Planning Application Ref: FG/37/19/T

Location: Elford House, 11 Ferring Lane, Ferring, BN12 6QU

Description of works: Crown reduction of maximum 6m to 1no. *Eucalyptus* tree, reduction of northwest canopy up to 2m to 1no. cedar tree, and reduce west/north side of 1no. *macrocarpa* and 1no. oak tree by up to 3m

Figure 2 Positions of final cuts

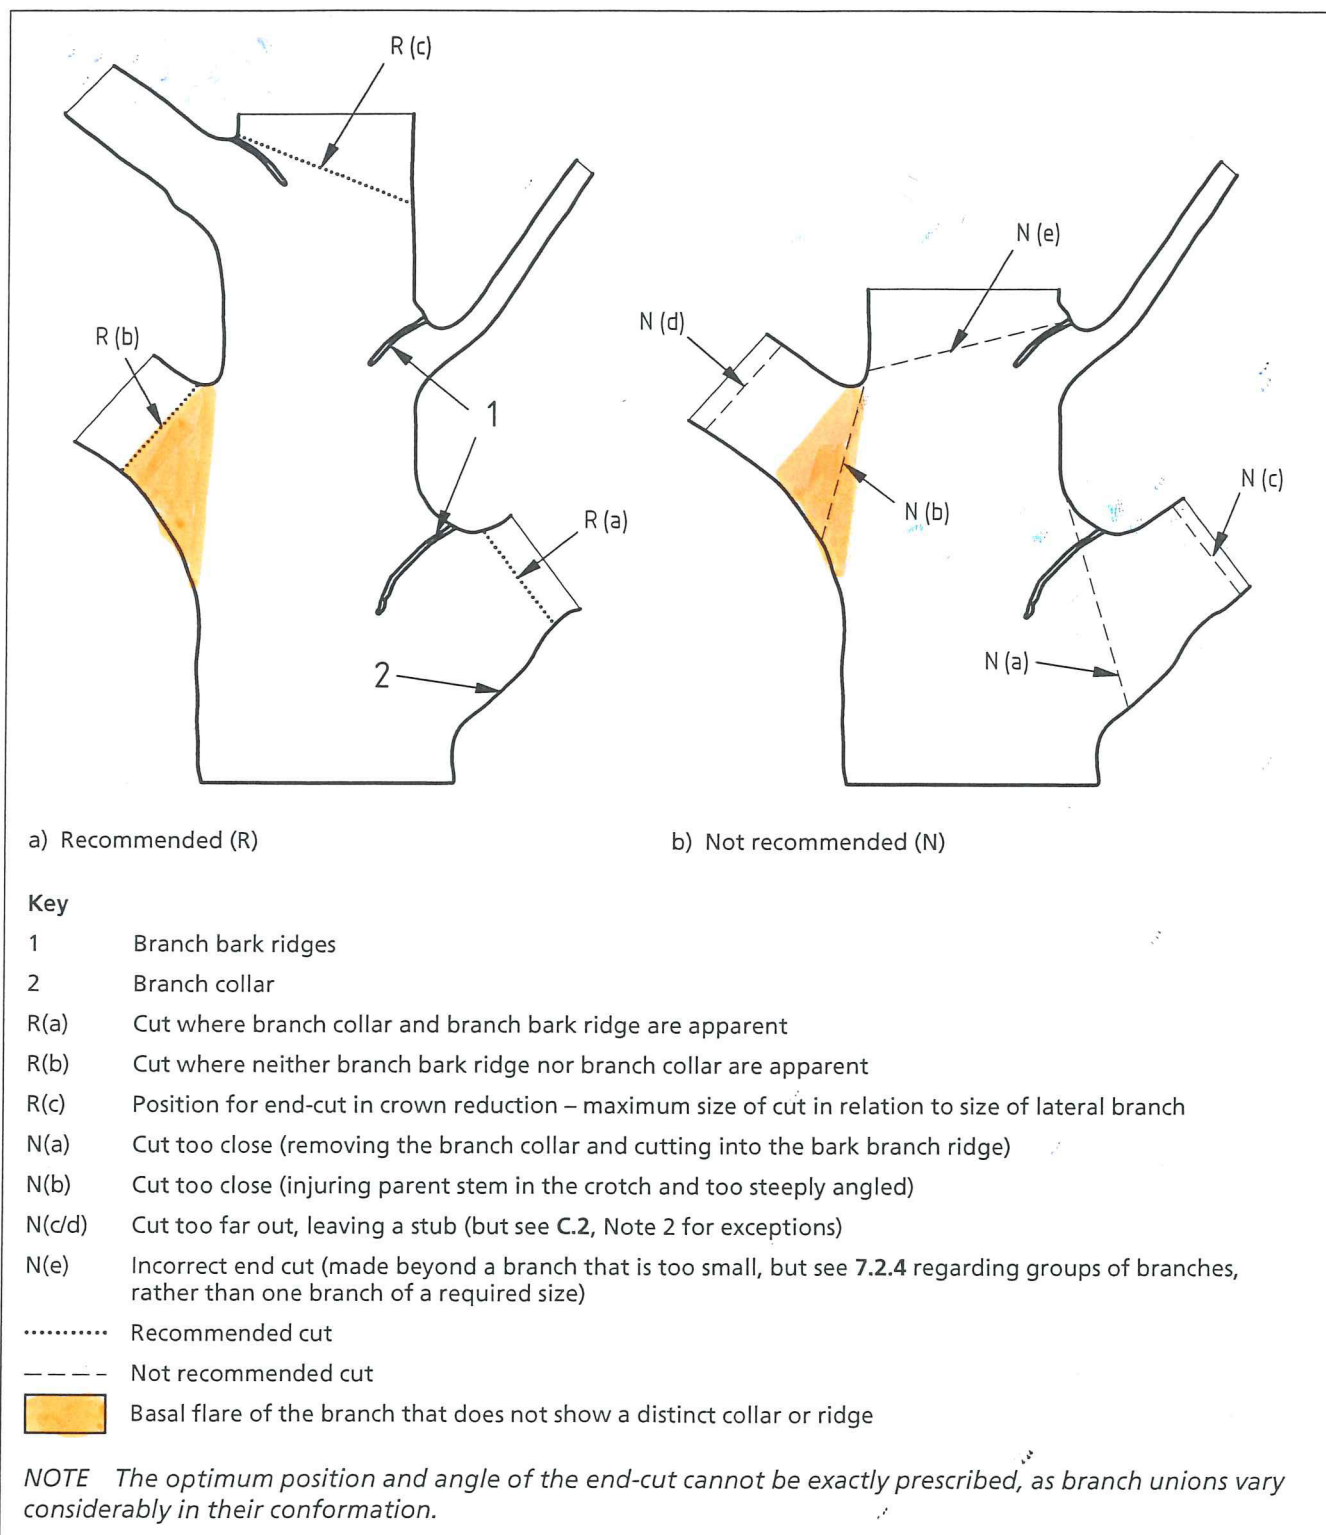
- Where whole branches are to be removed and final cuts made close to the trunk or branch union they are to be made as shown in Figure 2 of BS3998:2010
